MILITARY SPECIFICATION

DISPENSER ASSEMBLY

This amendment forms a part of Military Specification MIL-D-63123A(AR), dated 17 December, 1979, and is approved for use by the US Army Armament Research and Development Command and is available for use by all the Departments and Agencies of the Department of Defense.

FIGURE 1 Dispense pulse

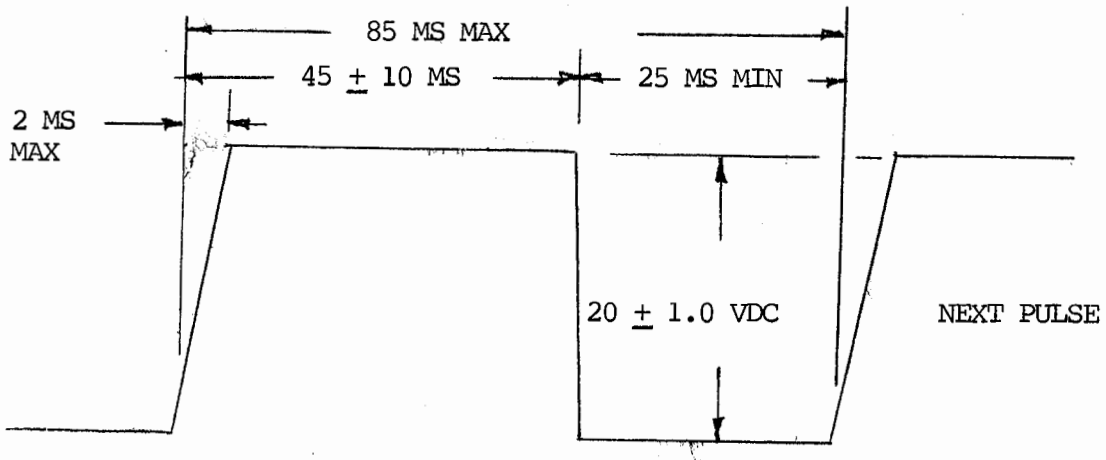
3.3.1, Change to read:

"The dispenser assembly, in both the chaff and flare modes upon receipt of thirty (30) pulses of 20 to 30 volt direct current (DC) dispense pulses conforming to Figure 1, shall fire 30 payloads in sequence, 1 through 30".

Add "Figure 1" as shown:
